NOTE: ALL CHANGES SHOWN IN RED

PROJECT DETAILS: SECTION 4.55 - ALTERATIONS AND ADDITIONS 1/2 DARLEY ST - EAST MONA VALE	DATE: MAY/20	DRAWN BY:	SCALE: 1:100 @ A3
DRAWING TITLE: GROUND FLOOR PLAN	JOB No: 800/20	CHECKED BY:	DRAWING No:

NORTH EAST ELEVATION

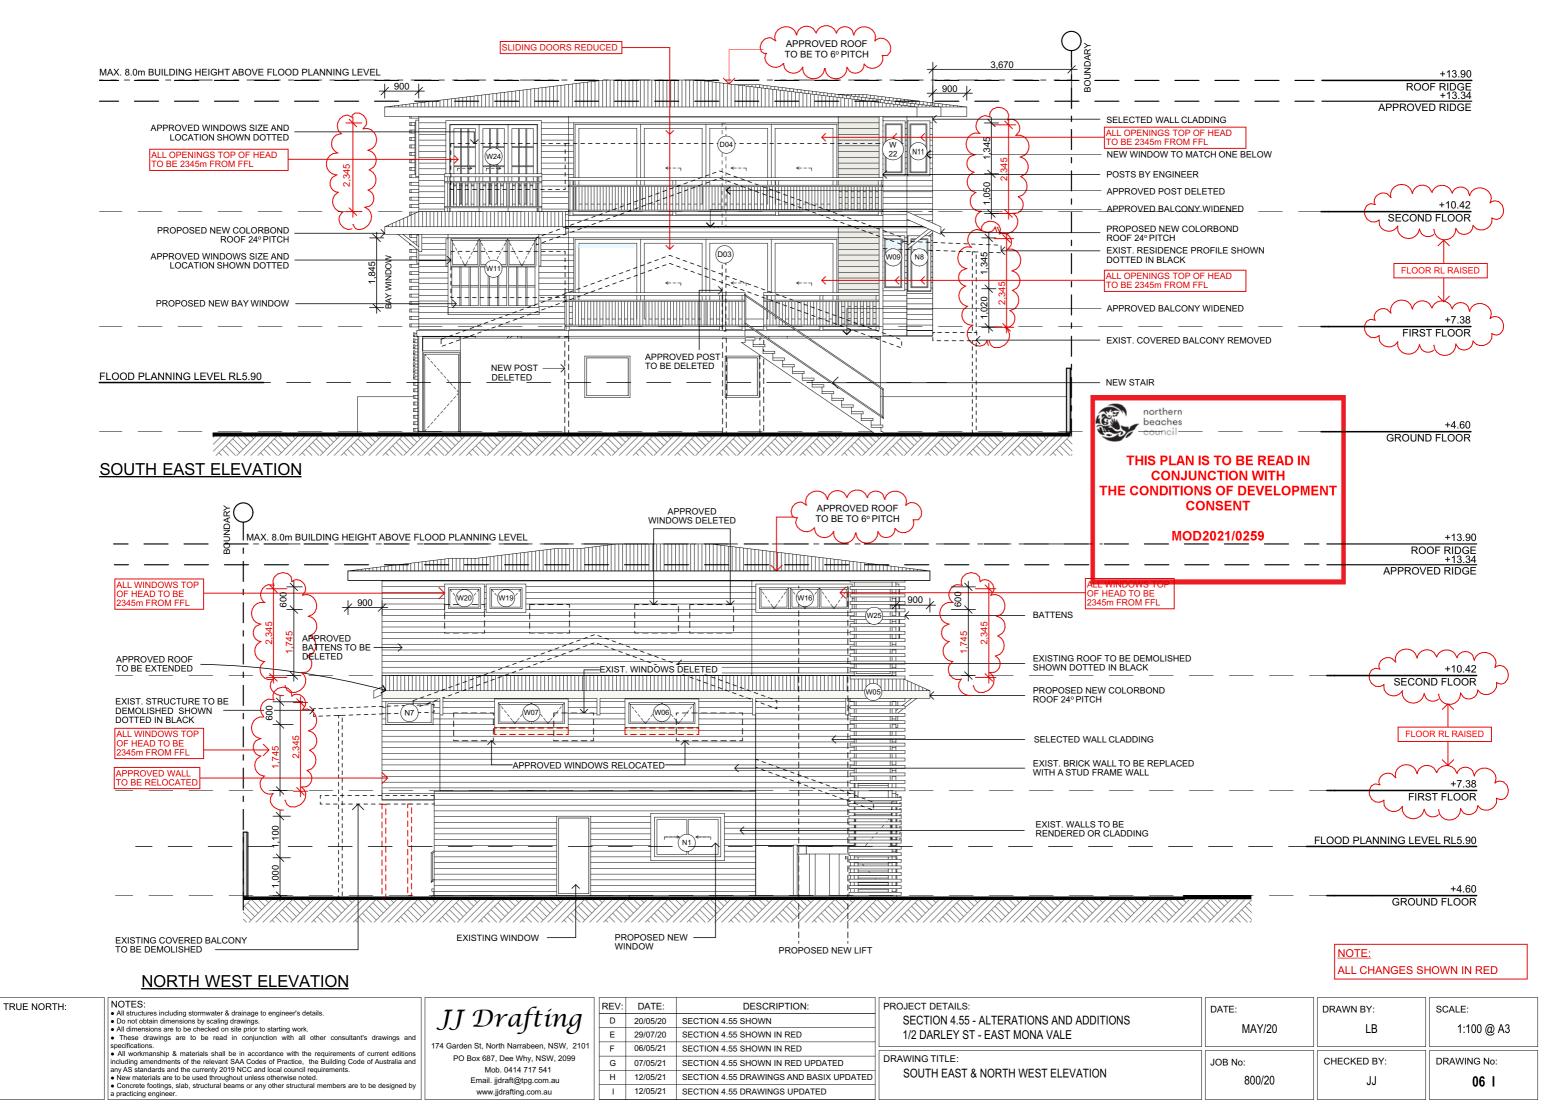
2,200 APPROVED WINDOWS SIZE AND LOCATION SHOWN DOTTED IN RED +13.89 MAX. 8.0m BUILDING HEIGHT ABOVE FLOOD PLANNING LEVEL +13.90 ¥ 900 ¥ ROOF RIDGE +13.34 ROOF RIDGE +13.34 APPROVED RIDGE APPROVED ROOF APPROVED RIDGE TO BE TO 6° PITCH NEW PRIVACY SCREEN ABOVE SOLID BALUSTRADE **BATTENS** APPROVED WINDOW TO BE REPLACED WITH A SOLID BALUSTRADE TO NCC SELECTED WALL CLADDING APPROVED BALCONY WIDENED +10.42 +10.42 SECOND FLOOR SECOND FLOOR PROPOSED NEW COLORBOND ROOF 24° PITCH EXIST. OPENING NEW PRIVACY SCREEN ABOVE SOLID BALUSTRADE ENCLOSED FLOOR RL RAISED **ALL WINDOWS TO** APPROVED WINDOW TO BE REPLACED WITH A SOLID BALUSTRADE TO NCC OF HEAD TO BE 8 EXIST. WALLS TO BE APPROVED BALCONY WIDENED +7.38 +7.38 RENDERED OR CLADDING FIRST FLOOR FIRST FLOOR PROPOSED NEW WINDOW TO REPLACE APPROVED DOOR FLOOD PLANNING LEVEL RL5.90 APPROVED EXTERNAL STAIRS +4.60 +4.60 **GROUND FLOOR** GROUND FLOOR **NEW POSTS** EXIST. OPENING ENCLOSED EXIST. WINDOW SIZE REDUCED APPROVED DOOR SIZE REDUCED TO 3.6m NEW BALCONY TO REPLACE EXIST. ROOF ON FIRST FLOOR

SECTION AA

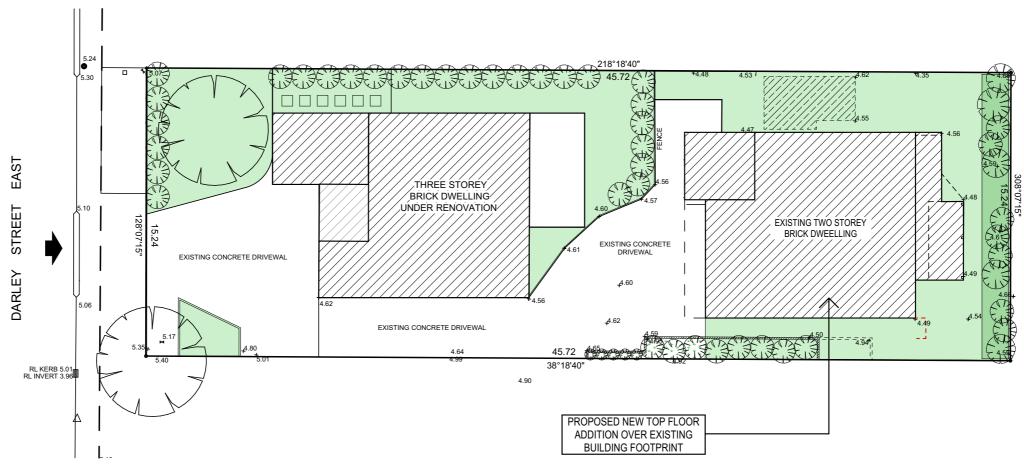
BOUNDARY BOUNDARY 2,200 EXISTING APPROVED ROOF TO BE TO 6° PITCH 3,225 **EXISTING** APPROVED ROOF PROFILE 3° PITCH +13.90 MAX. 8.0m BUILDING HEIGHT ABOVE FLOOD PLANNING LEVEL ROOF RIDGE +13.34 APPROVED RIDGE APPROVED KITCHEN TO BE REMOVED ALL WINDOWS TOP OF HEAD TO BE 2345m FROM FFL **NEW WET** +10.42 TV ROOM SECOND FLOOR ALL WINDOWS TO OF HEAD TO BE 2345m FROM FFL FLOOR RL RAISED NEW BI-FOLD DOOR PROPOSED NEW KITCHEN +7.38 FIRST FLOOR APPROVED BALCONY WIDENED FLOOD PLANNING LEVEL +4.60 **GROUND FLOOR**
